AGENDA
PLANNING AND ZONING COMMISSION MEETING
CITY OF CREVE COEUR, MISSOURI
MONDAY, NOVEMBER 2, 2020

APPLICATION TO PLANNING AND ZONING COMMISSION #20-032: PUBLIC FACILITY SITE DEVELOPMENT PLAN APPROVAL FOR A BUILDING ADDITION AND THE REDEVELOPMENT OF SPOEDE ELEMENTARY SCHOOL AT 425 N. SPOEDE ROAD

REPORT PREPARED BY: Whitney Kelly, AICP, City Planner

Figure 13: Close-up of the Site Development Plan showing the access drive along the south property line.

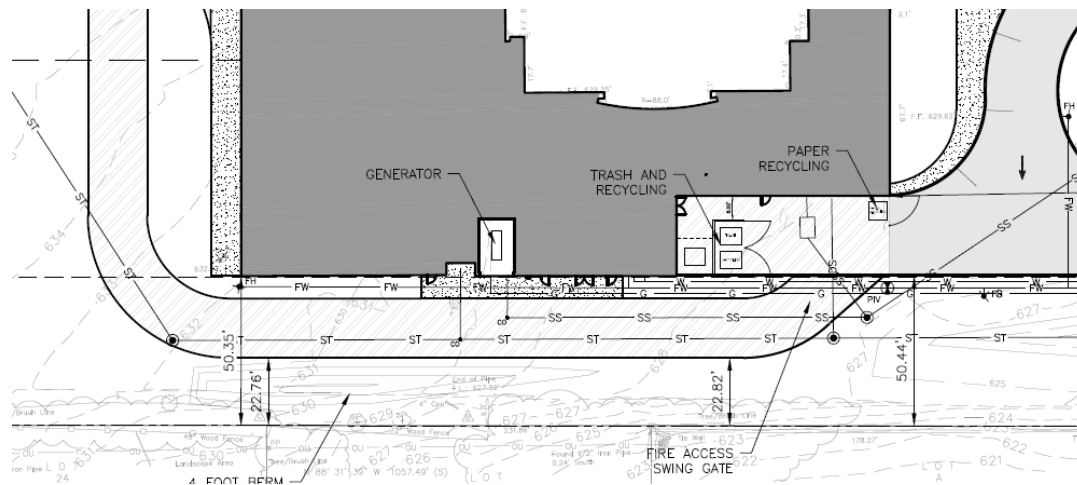
The site is preexisting non-conforming, where the existing parking lot and building are within the buffer yard. The proposed new building will sit behind the existing building, near the center of the site, due to the need to have the school in session while construction will be occurring. Once the new school is built the existing school will be torn down, and the front will become parking and school bus parking. The proposed new building is built to the 50 foot side yards at the north and south, however the walk ways around the building are within the buffer yard, at 45 feet along the north property line, as well as the emergency access drive on the south which is approximately 22.82 and 22.76 feet from the south property line.

While the proposed site plan does not provide for a consistent setback along Spoede Road with the surrounding residential properties, and the service drive is within the recommended landscaped buffer area, the proposal does represent an improvement in other areas over the existing, by decreasing the amount of coverage within the buffer yard, reducing the overall site coverage, and providing enhanced landscaping along N. Spoede Roads, and along the north and south property lines, to screen parking areas and service drive, from the adjacent properties.

Figure 17: Information regarding proposed gate for the Emergency Access.

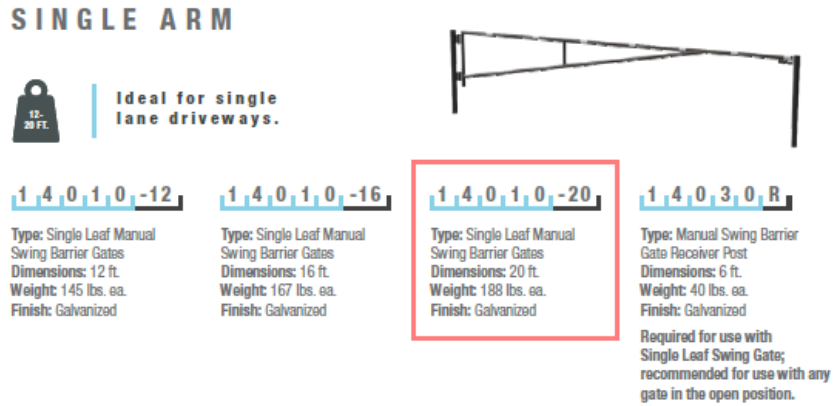
In addition to Section 405.470, regulations for conditional uses are also found within the underlying zoning district, in this case the A Single-Family Residential district. Section 405.250(E)(4)(a)(c)(e) and (f) of yard and setback requirements requires a minimum front, side and rear yard setback for conditional uses of 50 feet, plus requiring a buffer yard of 25 feet on all sides that abut the single-family use in the residential district. The minimum required buffer yard shall be increased in 5-foot increments, up to a maximum of fifty 50 feet, for each acre of the subject property. All acreage shall be rounded up to the next whole number for buffer yard calculations purposes. An additional two (2) feet of buffer yard shall be provided for every foot of building or structure height exceeding forty-five (45) feet. The buffer yard shall not contain any impervious surface and shall be landscaped and provided with other screening devices as deemed appropriate by the Planning and Zoning Commission. Therefore, for a 9.79-acre property, and the building under 45 feet, the buffer yard is 50 feet, where adjacent to residential developments. As discussed above, the proposed design does not comply with the buffer yard requirements, as the walkway on the north side of the building is at 45 feet, and the asphalt emergency access on the south is at 22.76 feet from the south property line. The Applicant states that the Fire

District would not allow grass-crete permeable pavers, therefore this will be an asphalt drive and will be gated and only be used for emergency vehicle access and refilling the diesel generator and access will be controlled by building operations. While not fully meeting the requirement, we need to point out that it is significantly improved over existing conditions and the use of these encroachments are limited to occasional use.

Figure 18: Site Plan emailed on 10/29/2020 showing the sidewalk extension along Spoede Road. The areas in red indicate where the sidewalks should be extended to coincide with full length of the parking spaces.

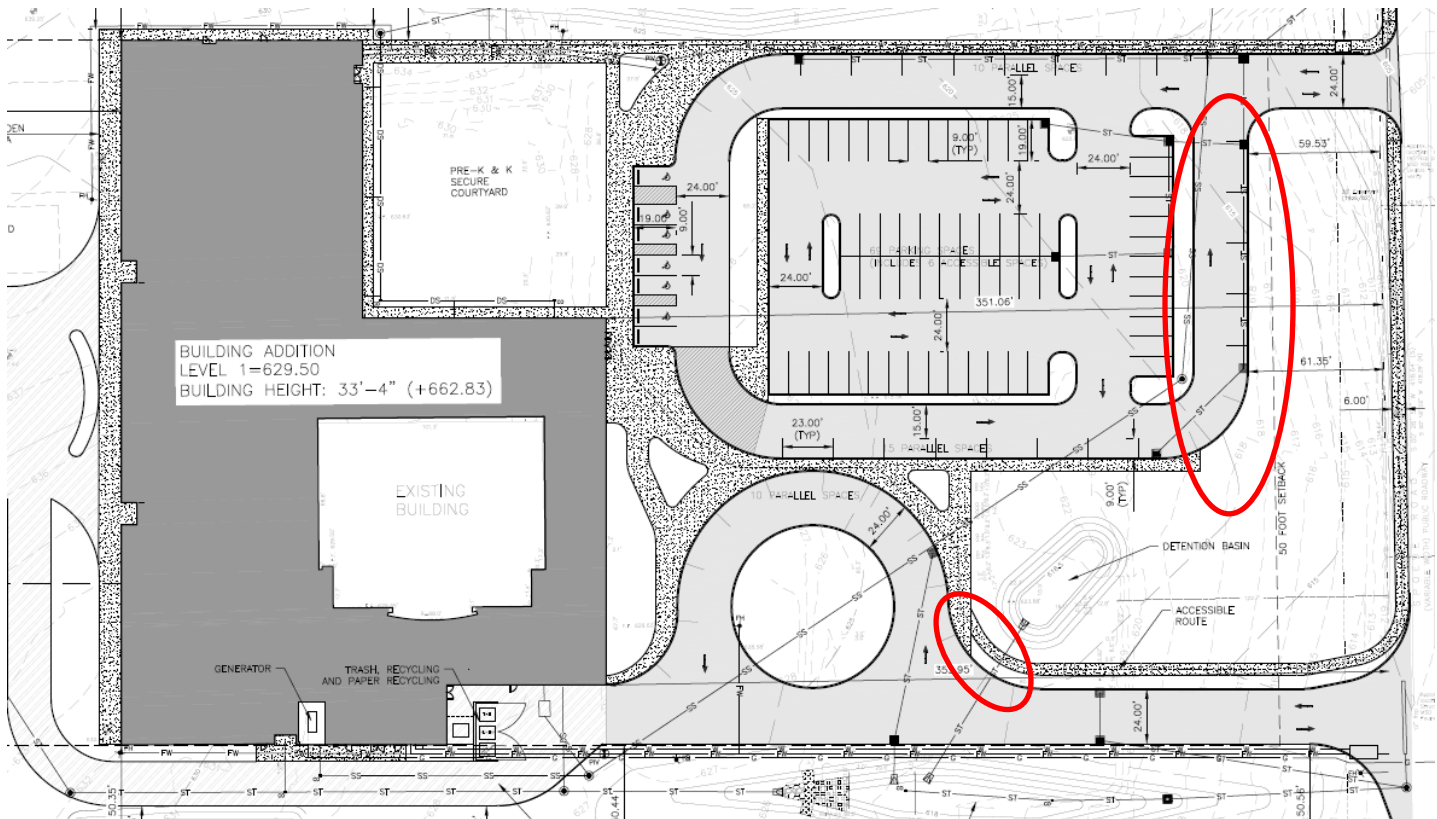
Section 405.730 Sidewalks requires that all internal sidewalks shall be safe, clearly defined and direct, buffered from the street vehicular traffic and parking areas by a minimum of 3 foot greenspace or landscape area, provide safe clearly defined and direct access between buildings from the principal building's entrance to the public side walk, and all internal sidewalks in non-residential developments shall be at least 6 feet in width or 8 feet if used as a curb stop, and the use of textured or tinted materials for pedestrian crossings shall be utilized where pedestrian circulation paths cross a vehicular route. All sidewalks within the parking area are shown at 9-feet in width, but in other areas, the internal sidewalk is 5-feet in width with greenspace separation from the road and drive aisles. The site plan submitted on October 26, 2020, indicated that the accessible walkway was located along the south entrance. A revised Site Plan was emailed on October 29, 2020, to show that a 6-foot-wide sidewalk adjacent to the curb

along the west side of Spoede Road is extended the public sidewalk southward to the new walkway. However, this area has utility poles near the curb line, and therefore the sidewalk will need to be beyond these utility poles. Therefore, Staff has included a condition that all sidewalks are to be a minimum of 6 feet in width, and that the sidewalk along N. Spoede Road should be separated from the curb to avoid the utility poles. Public Works has requested that the sidewalk be extended across the southern entrance with a ramp at the south property line and that all sidewalks along N. Spoede Road are to be placed within an easement. Additionally, the internal sidewalks within the parking areas should be extended to the full length of the parallel parking, as shown in Figure 18. Staff has provided conditions to address all of the recommended sidewalk revisions for staff approval as part of the permit review.

4. The sidewalk along N. Spoede Road to the accessible pathway at the south entrance shall follow the configuration as shown on the revised Site Plan emailed on October 29, 2020, subject to the following revisions: the sidewalk is to be detached from the curb and placed on the property side of the existing utility poles, located within an easement granted to the City for public use and maintenance, and be extended across the southern entrance with a ramp on the south side subject to final approval by the Public Works Department.

Figure 20: Area for the trash enclosure the Paper Recycling from the revised site plan emailed on 10-29-2020

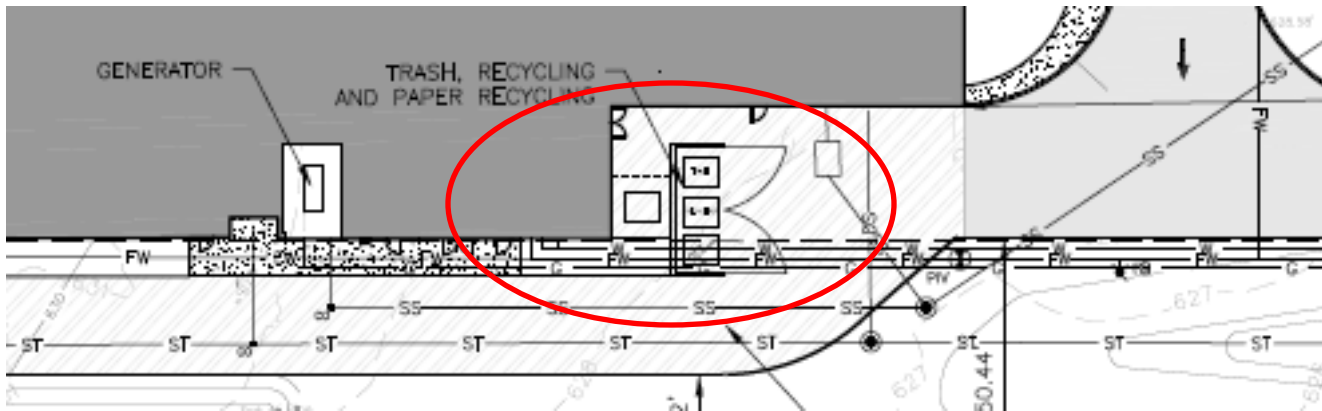
The Design Guidelines also recommend that services and trash or utility areas should be positioned to minimize view and visual impact. Building equipment and utilities are to be located, designed and/or screened to minimize visual impact on public streets, surface parking lots and neighboring properties. Accessory structures, with the exception of the front canopy, are to be behind the building line and if detached shall be a minimum of 10 feet from the principal structure, per Section 405.460(D) Location of Accessory Uses and Structures. If the trash enclosure is attached to the main building than it should comply with the requirements of the principal building. Details of the trash enclosures have not been provided, and it should be noted that the revised site plan emailed on October 29th shows the trash area to be at 45 feet within the building setback and buffer area. The rendering of the south entrance also shows that this area will be visible from Spoede Road. Therefore, Staff has included a condition that any trash and recycling dumpsters shall be located behind the front of the building and properly enclosed with brick materials consistent with the main building for the Zoning Administrator's approval.

Figure 21: Close-up of the Photometric Plan submitted 10-2-2020 of the access drive closest to the south property line.

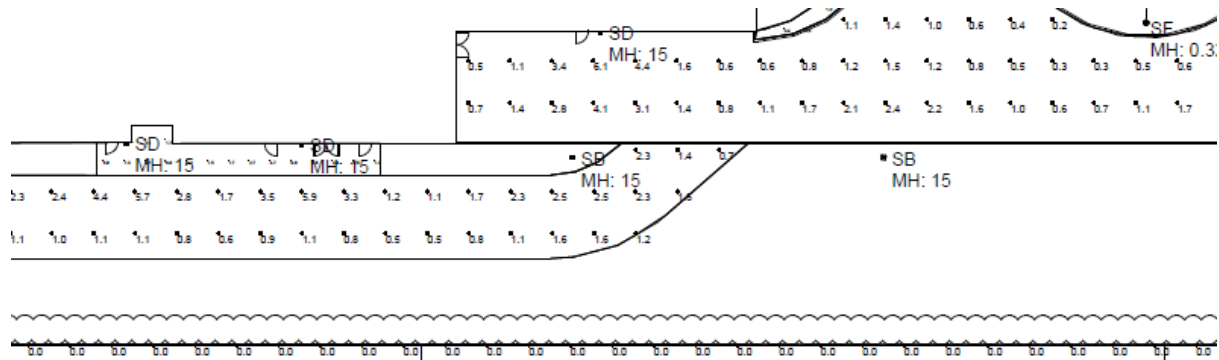
The proposal includes lighting that is consistent with Section 405.680 Lighting regulations of the Zoning Ordinance. McClure Engineering, the Applicant's lighting engineer, states that the new lighting for the school will include pole mounted fixtures throughout the parking and drive areas. The fixtures will be the LSI LED Enterprise with a 16 feet maximum height, including the base. Designed calculations are targeted for the low end of IES recommendations. The fixtures will be 100% downlight and shielded as required. Design will reflect 0 foot-candles on the property line. These lights are similar to those that were recently approved in 2017, in the dark bronze color.

9. All lighting shall be in compliance with the Information submitted by McClure Engineering, submitted on October 2, 2020, and shall be installed or modified to be in conformance with Section 405.680, Lighting, of the Zoning Ordinance.

1 OVERALL ROOF PLAN
1/16" = 1'-0"

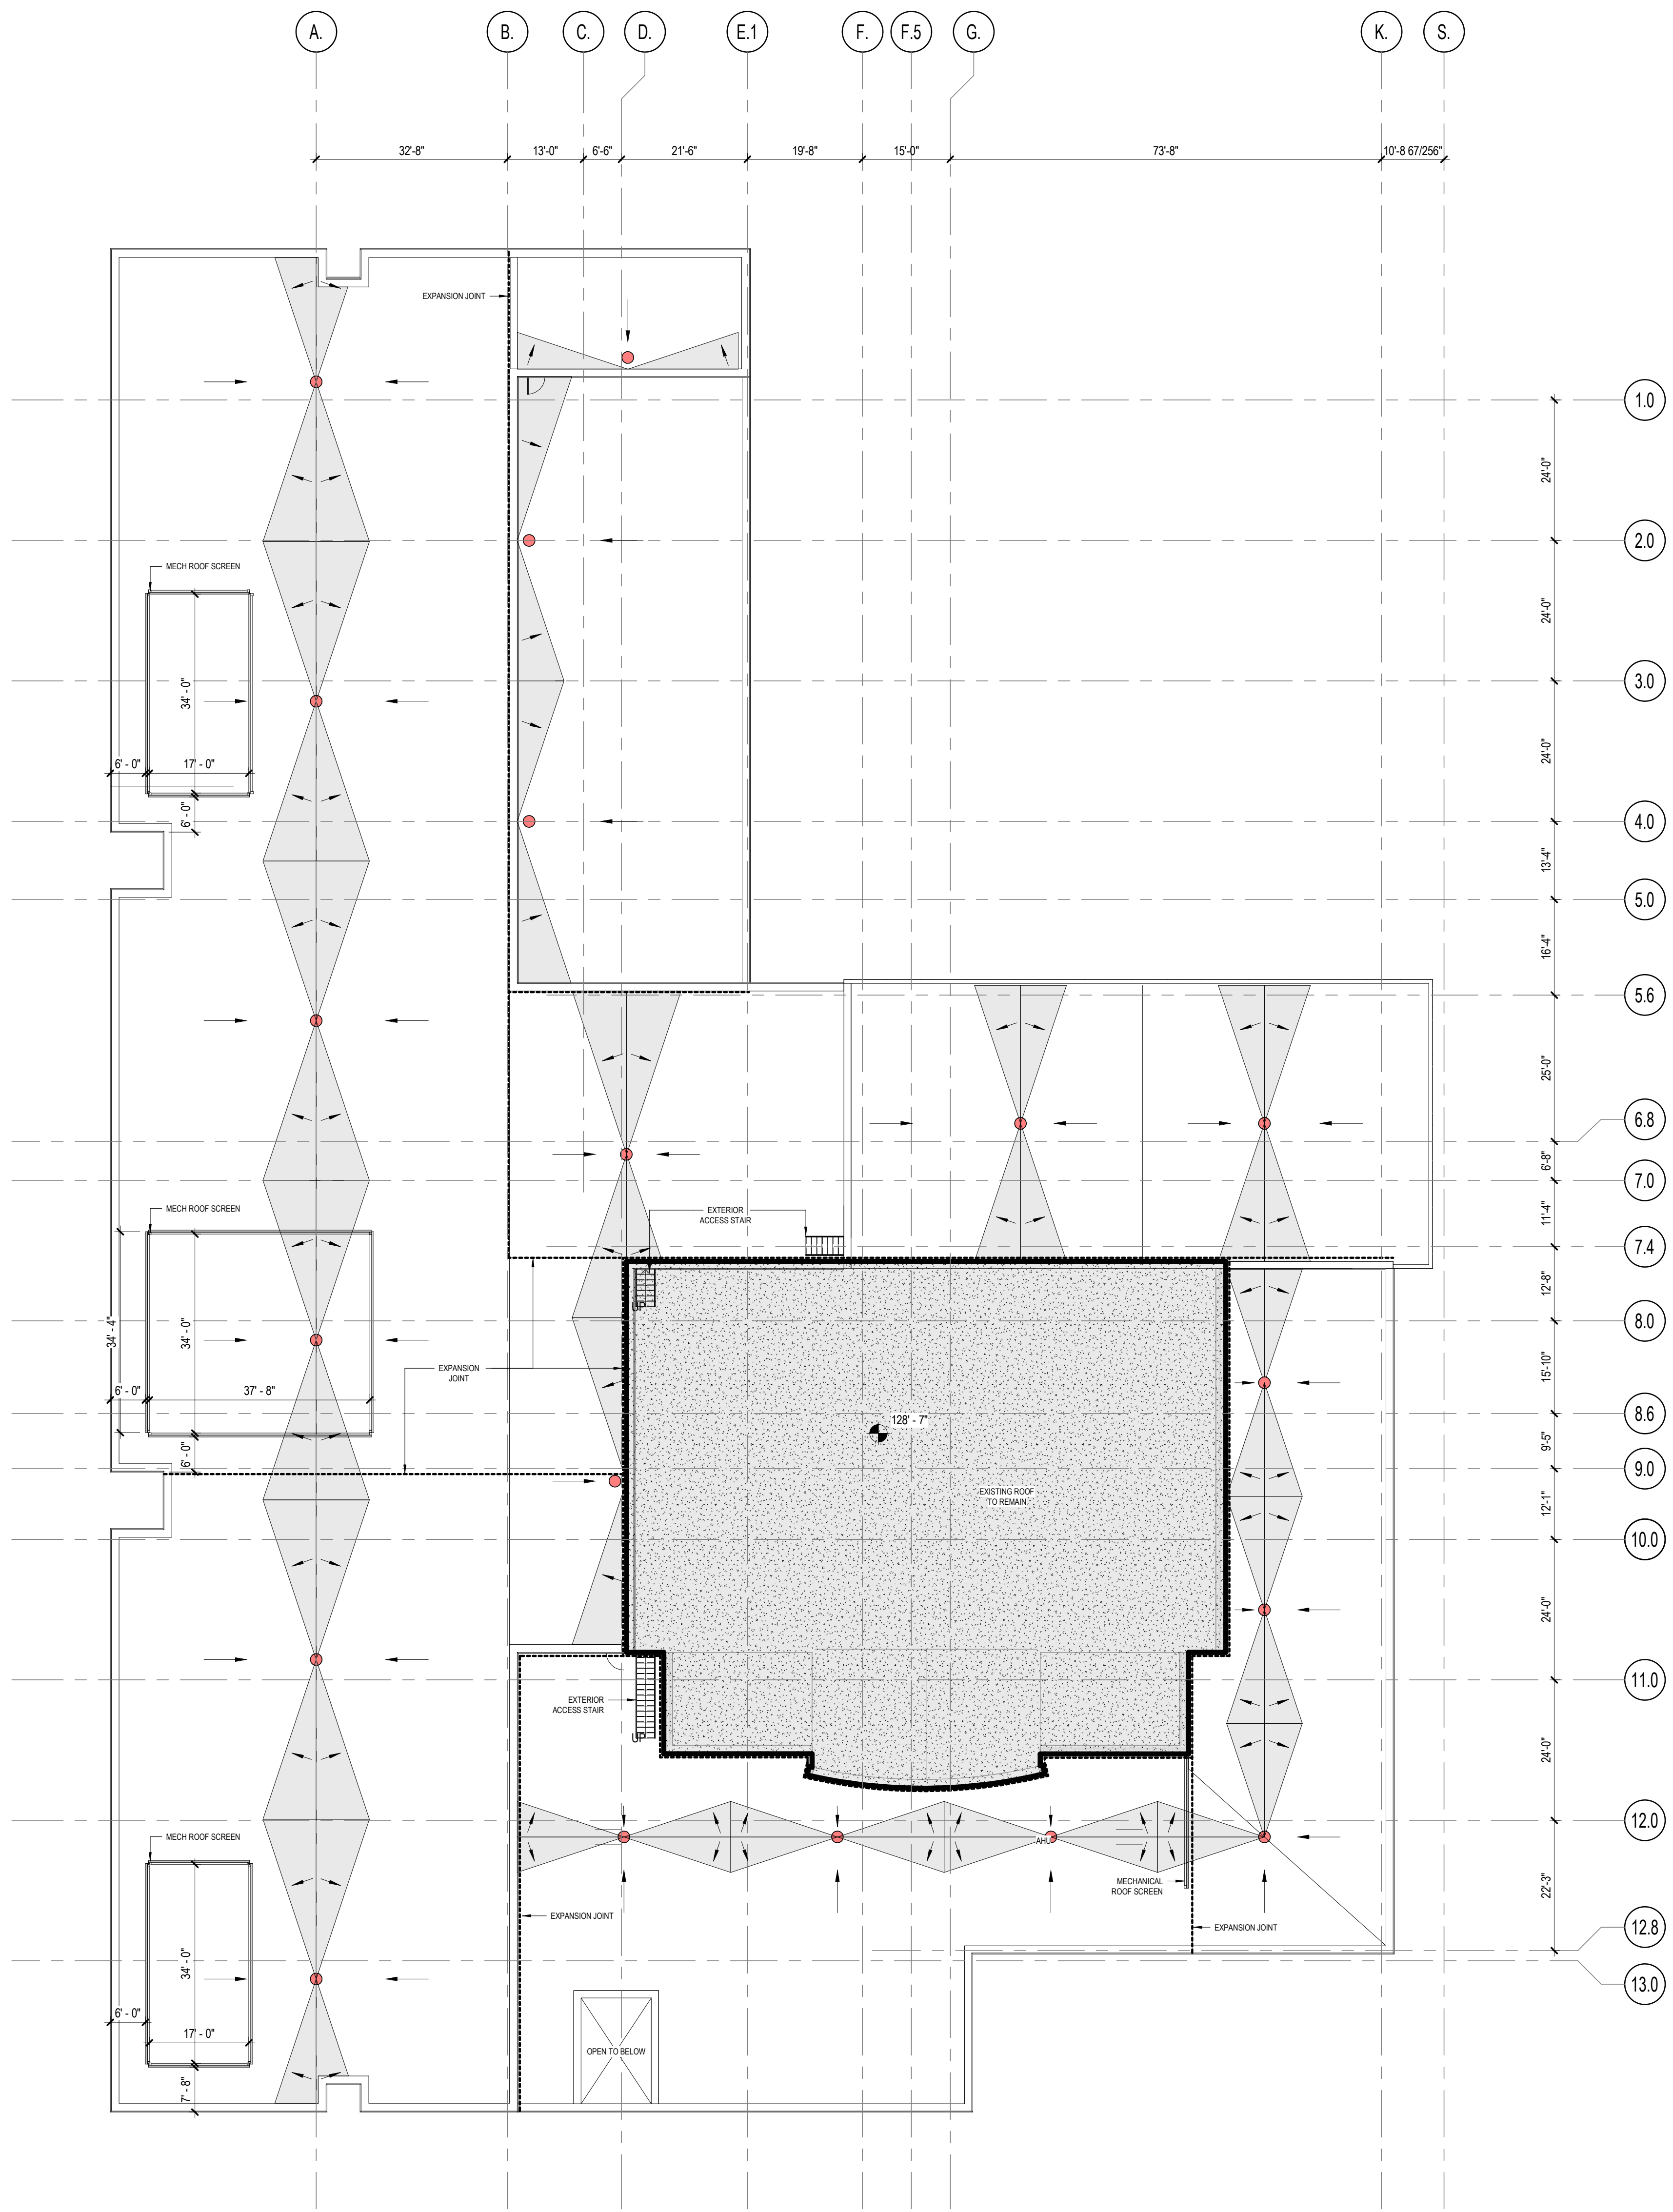
The Design Guidelines recommend that building elements, such as parapet walls, penthouses or screen walls should be treated as an integral part of the architecture, incorporating similar design, detail and materials as the primary structure. All rooftop equipment, including, but not limited to, satellite and other

telecommunication equipment, air handling units, elevator equipment, cooling towers and exhaust fans are to be screened from view. Building screens should be part of the architectural design with similar detailing and materials and not appear as add-ons. The drawings indicate that the three different screened areas do not fully meet with these recommendations as they appear as add-ons to the roof and are not well-integrated., two of which are visible in the renderings from Spoede Road. The elevations are also showing several roof access ladders and roof staircases that are visible.

6. The rooftop mechanical screening should be a flat metal to better integrate the material with the building.
7. The Applicant shall provide proper tree protection of the existing tree large caliper trees along Spoede Road and comply with Section 405.540 Landscaping of the Zoning Ordinance.
